BCA ASSESSMENT REPORT

**Oakdale West
Horsley Park**

Client: Goodman Property Services

Date: 29.03.2016

Figure 1 – Areas of Non-Compliant Perimeter Vehicular Access per BCA C2.4.

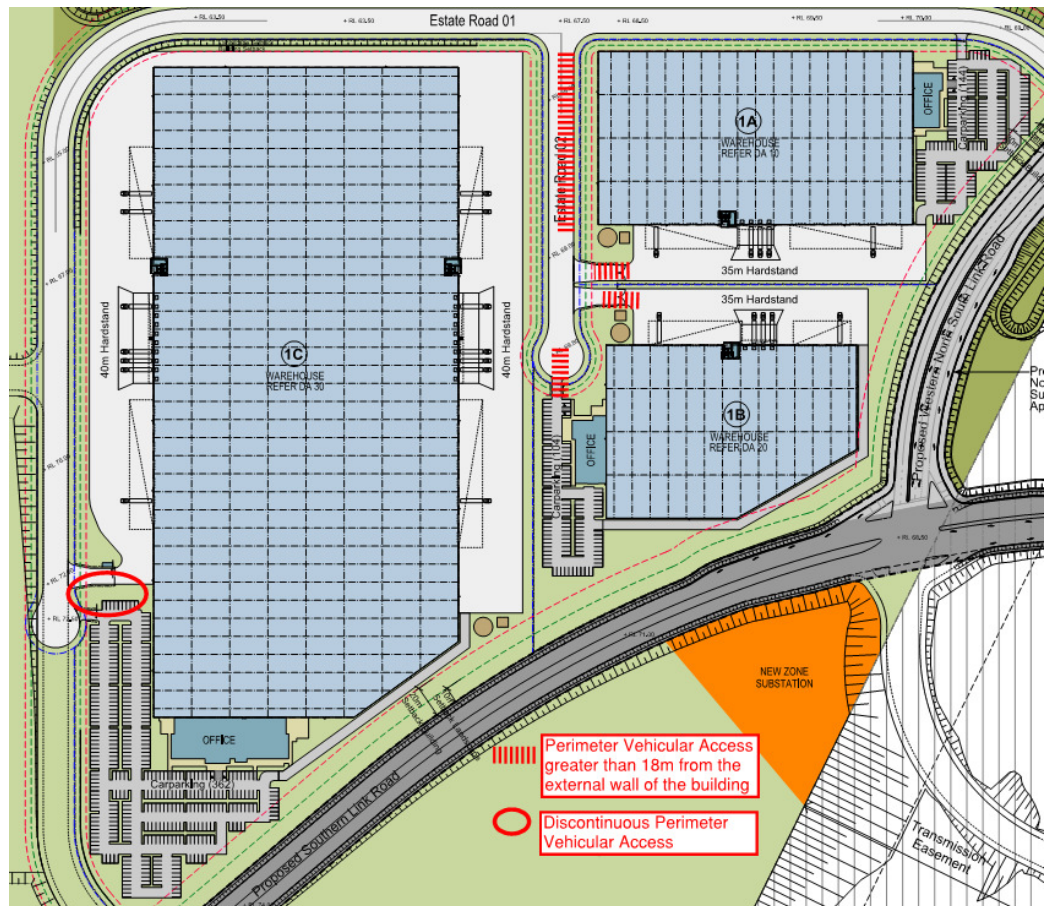
Comments: The proposed warehouse buildings do not comply with the provisions of C2.4 and thus the following non-compliance issues are required to be addressed as an alternative solution by the Fire Safety Engineer to demonstrate compliance with Performance Requirement CP9 - refer to the dot points and the diagram below for details of the proposed non-compliance issues:

- Vehicular Access is provided around the four (4) sides of all of the Warehouses however, it is greater than 18m from the external walls of Buildings 1A & 1B- refer to diagram below.
- Vehicular Access is discontinuous in the SW corner of Building 1C - refer to diagram below.
